**Gainesville Community Redevelopment Agency
Cornerstone Eastside Development**

Countywide Wetland Protection Code Application

Alachua County Board of County Commissioners

July 11, 2023

Proposed Wetland & Wetland Buffer Impacts

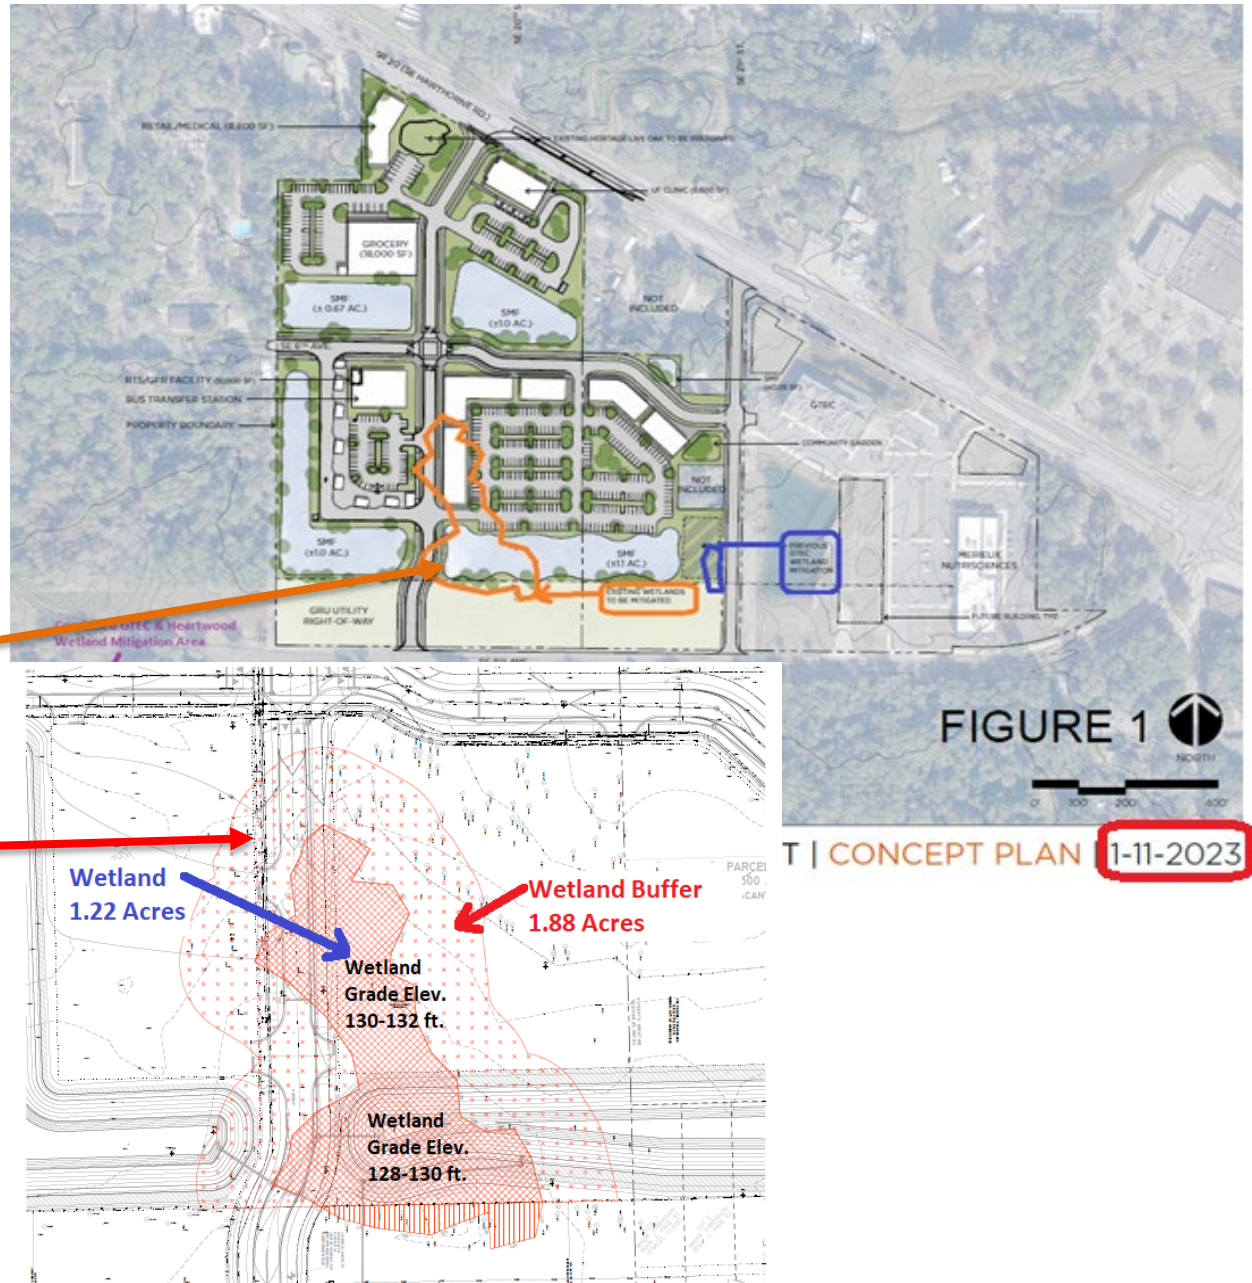
January, 2023 –
Proposed concept
plan includes impacts
to 1.22 acres of
forested wetland
habitat and adjacent
1.88 acres of forested
wetland buffer
(buffer width 75 ft.).

Wetland Forensic Assessment

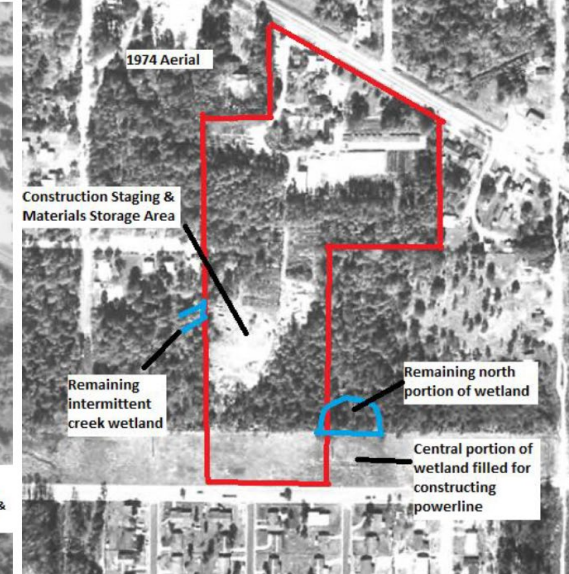
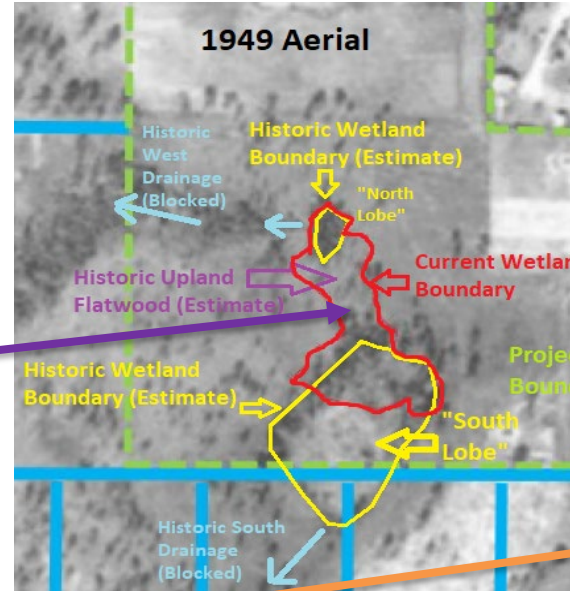
- *Historically upland flatwood habitat separated two isolated wetlands.*
- *By mid-1970's, majority of southern wetland filled by construction activities.*
- *Fill material blocked wetland from draining, converting flatwood to wetland.*

Current & Future Drainage

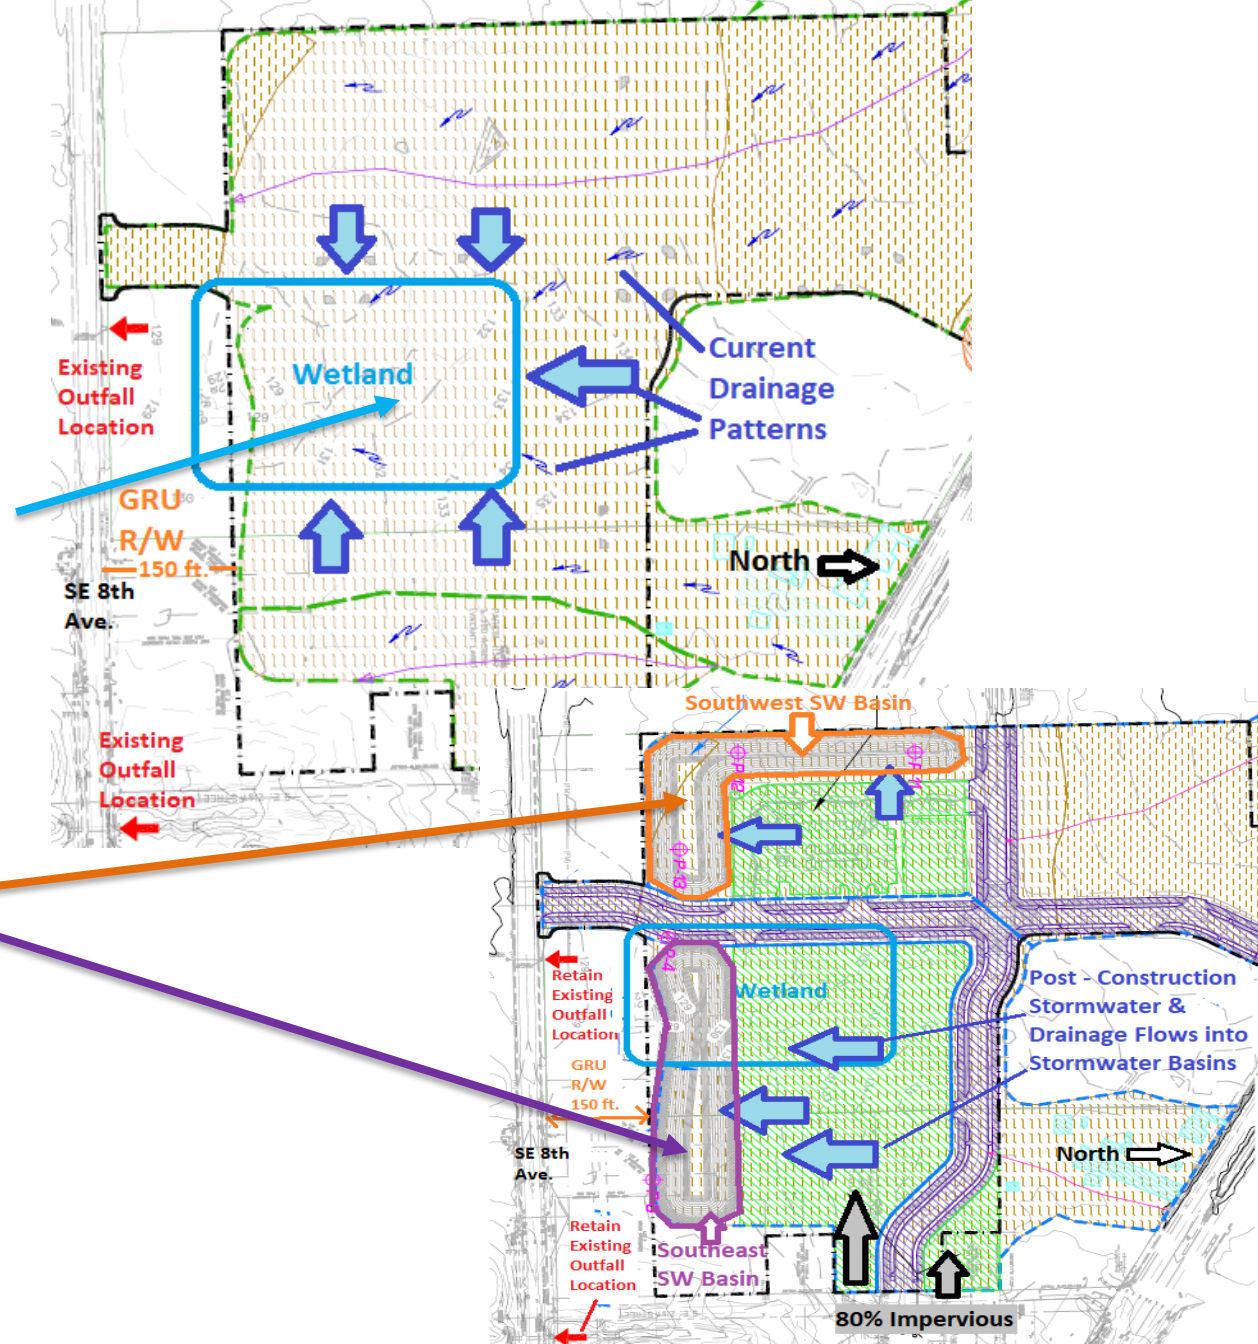
- **Current Drainage**
Majority contributing watershed flows toward wetland.
- **Post-Construction Drainage**
Contributing watershed diverted to stormwater basins for water quality treatment.
- **Proposed 80% impervious**
conditions within southern half of the project site.

Wetland / Buffer Preservation - Technical Assessment Alternative #1

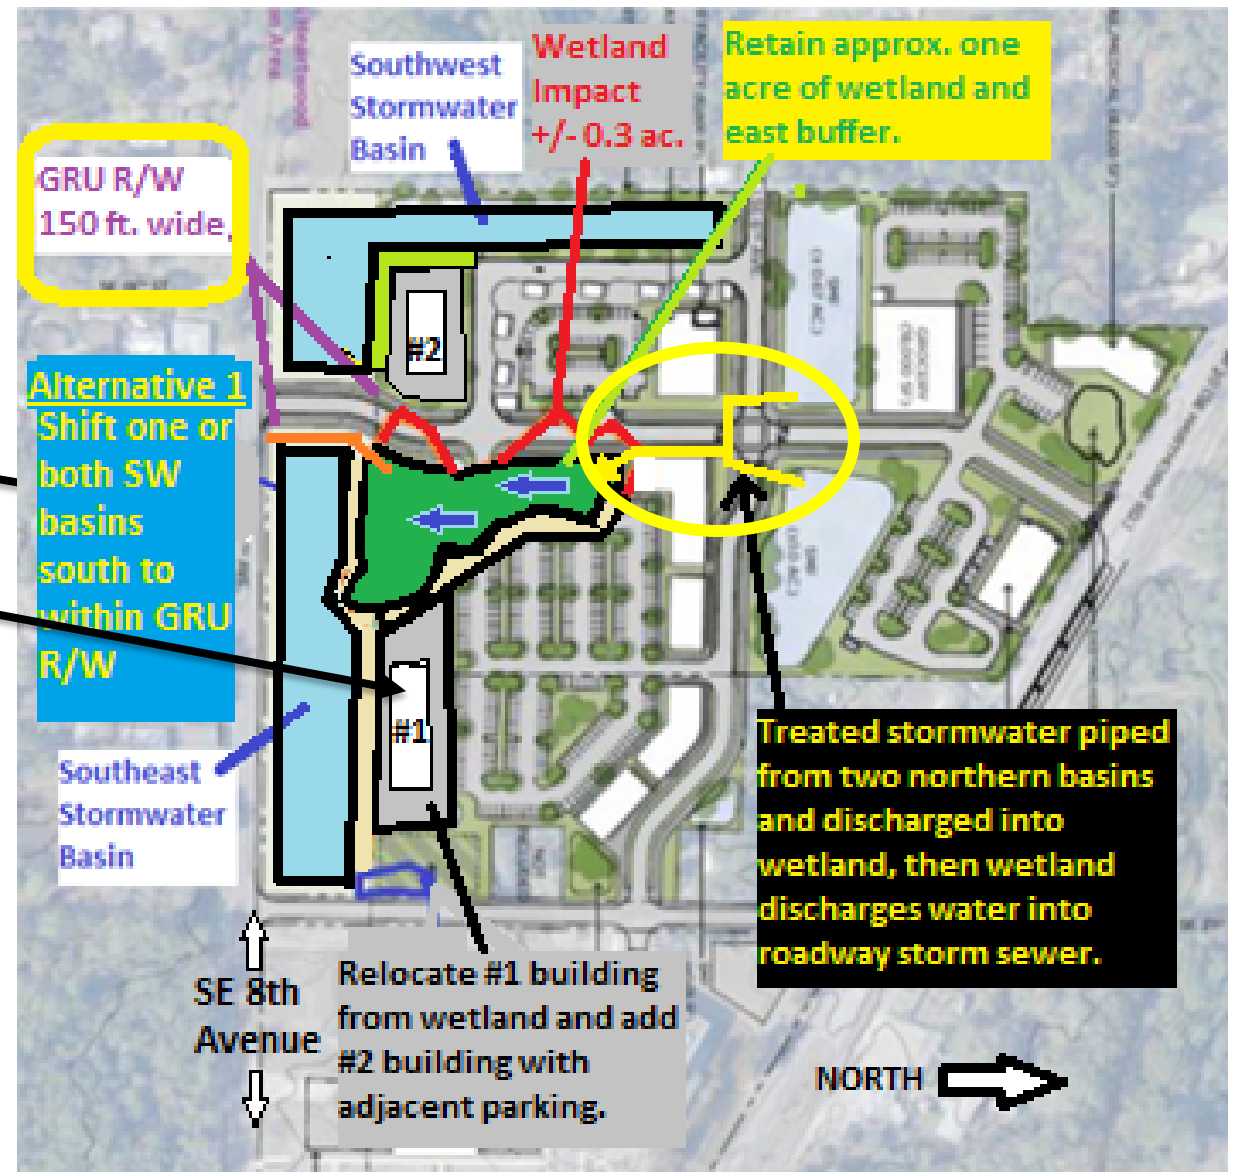
- *Shift southeastern stormwater basin to within GRU R/W.*
- *Relocate building to current proposed stormwater basin location (#1 on figure).*
- *Discharge treated stormwater from two northern basins through wetland to retain seepage hydrology.*
- ***Restriction – other than proposed access road, GRU not supportive of additional facilities within the R/W.***

Alternative 2 - Southeast Stormwater Basin & South Lobe Wetland
Dry Season Hydrology

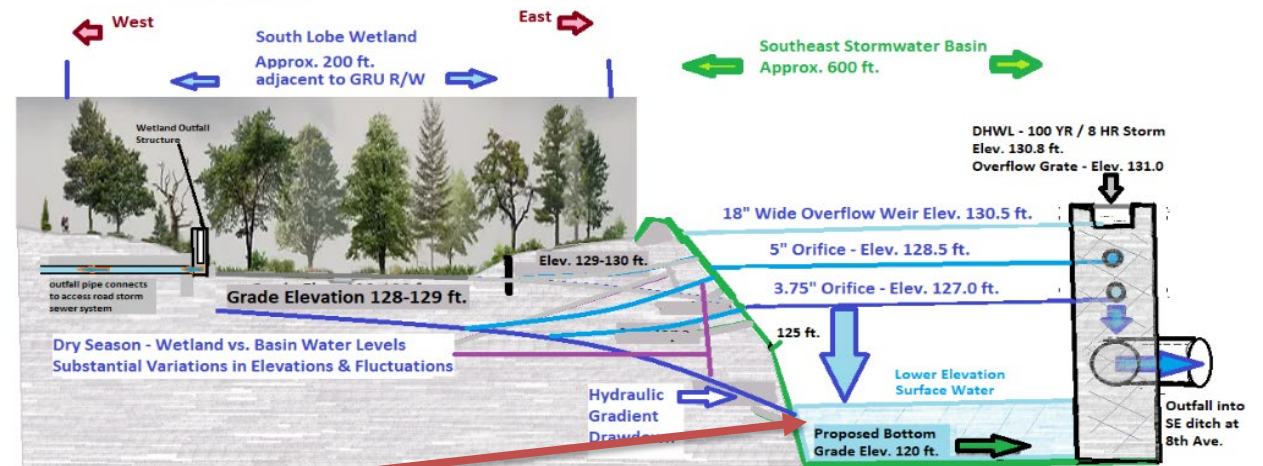
- *Reconfigure southeastern stormwater basin to preserve higher quality South Lobe portion of the wetland.*
- *Stormwater basin's wet detention design retains appropriate seepage hydrology of the South Lobe during rain seasons.*
- *Restriction – wet detention requires excavation of deep basin, hydraulic gradient drawdown in the dry season limits capability to retain seepage hydrology.*

Wetland / Buffer Preservation - Technical Assessment Alternative #3

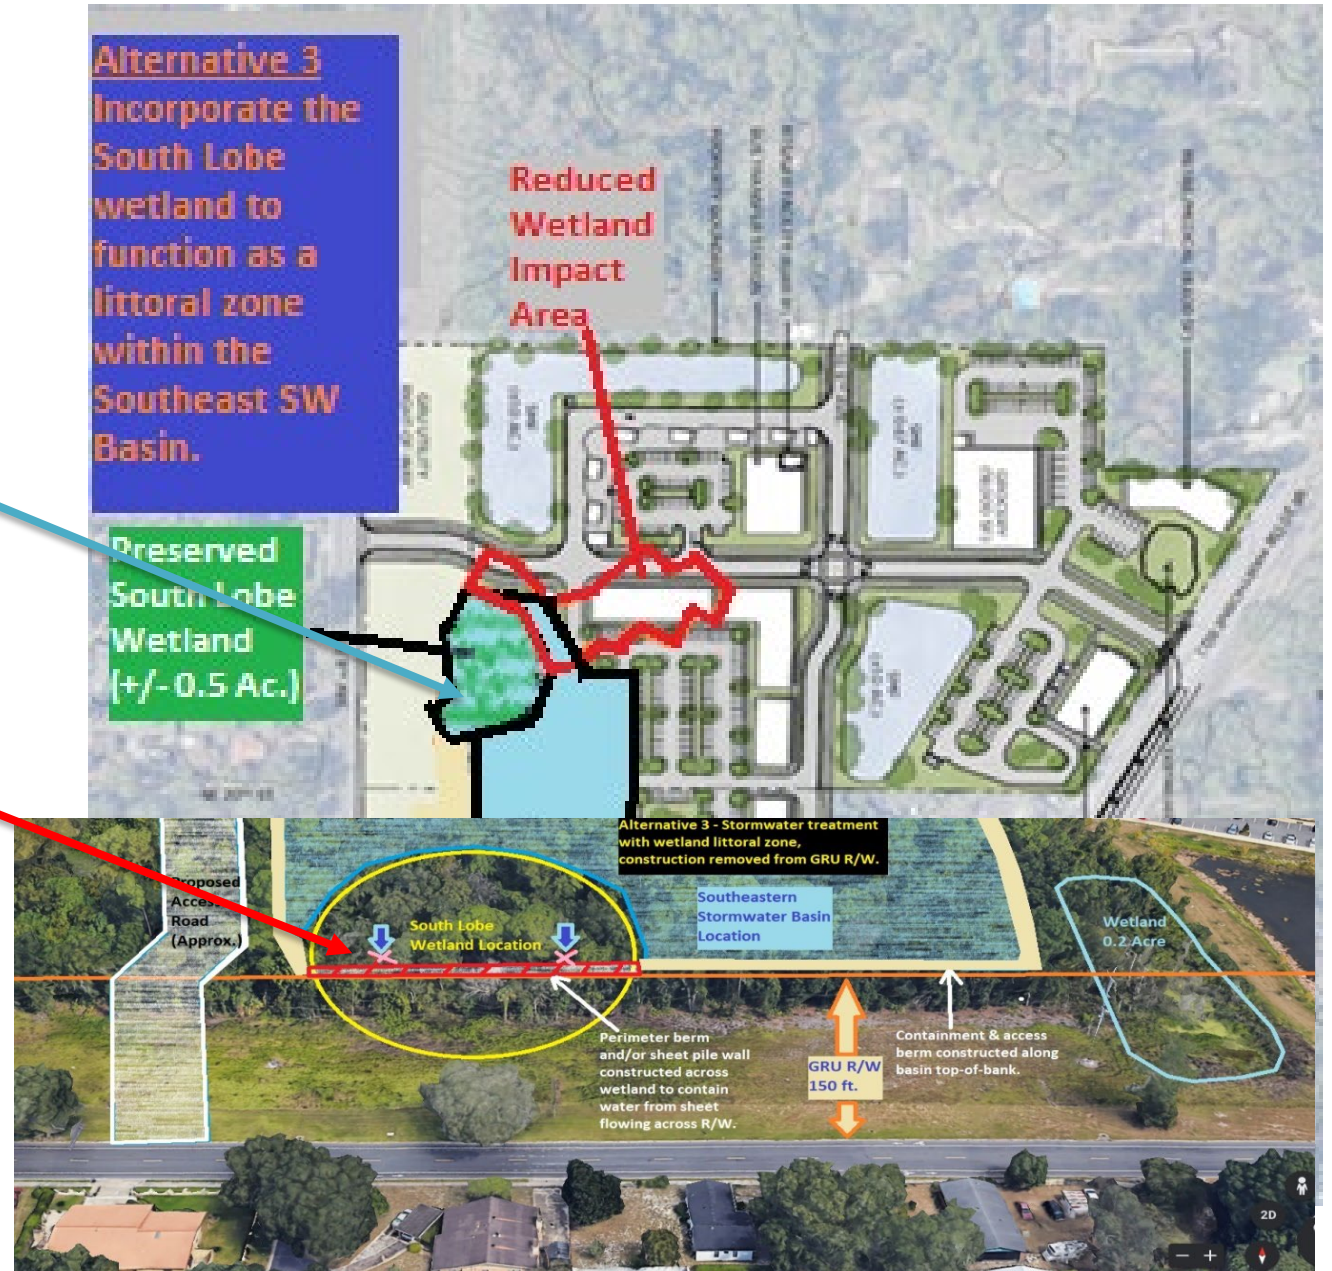
- *Incorporate South Lobe into southeast basin to function as littoral zone for stormwater treatment.*
- *Extend containment berm and/or install sheet pile wall across South Lobe wetland to contain surface water from sheet flow south over GRU R/W.*
- *Limitation – Smaller wetlands incorporated into treatment basins experience longer durations of surface water; difficult for seepage wetland to sustain habitat.*

Wetland / Buffer Preservation - Technical Assessment Summary

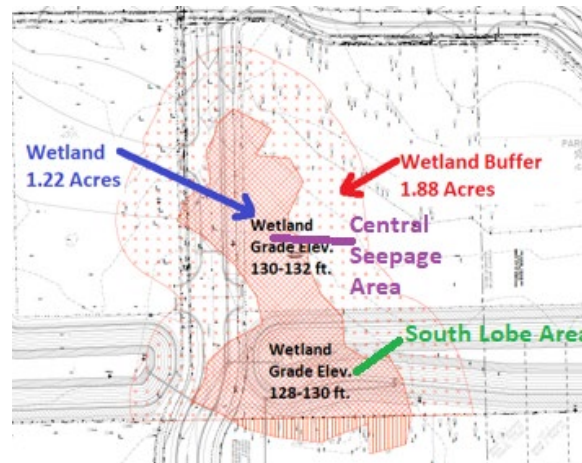
- *The seepage hydrologic features of this wetland will be difficult to sustain due to major changes of the drainage patterns and high percentage of impervious conditions.*
- *Too many factors will result in the wetland suffering through cycles of receiving too much and/or too little contributing water to sustain appropriate habitat conditions.*
